Stormwater Detention and Infiltration Design Data Sheet

Stormwater Facility Name: **JeniShay Farms**

Facility Location & Jurisdiction: **El Paso County**

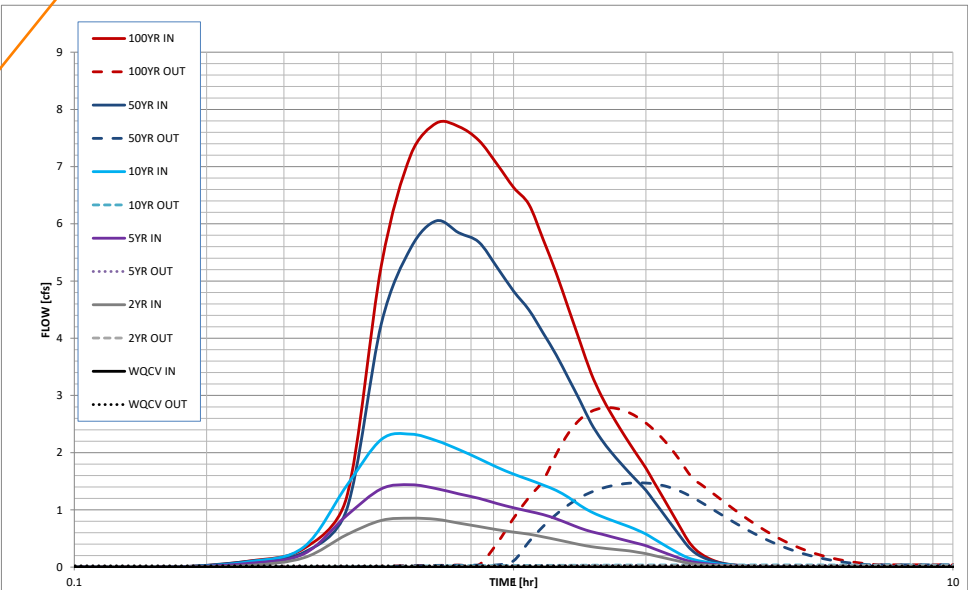
Page 19 of the Soils Report states that there is both Type B and Type C soils. So how is this pond going to be 100% Type B? Discuss in report text above.

Where did they these values come from?

Routed Hydrograph Results

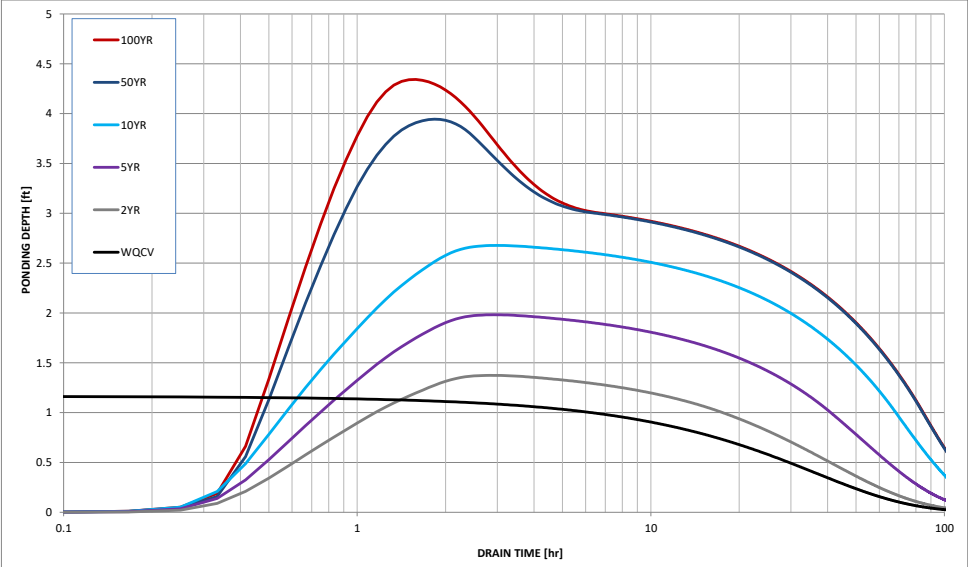
These values are quite different from the UD-Detention spreadsheet. Why? All inputs except flowrates (not on UD) are the same. Look into this please and revise as needed.
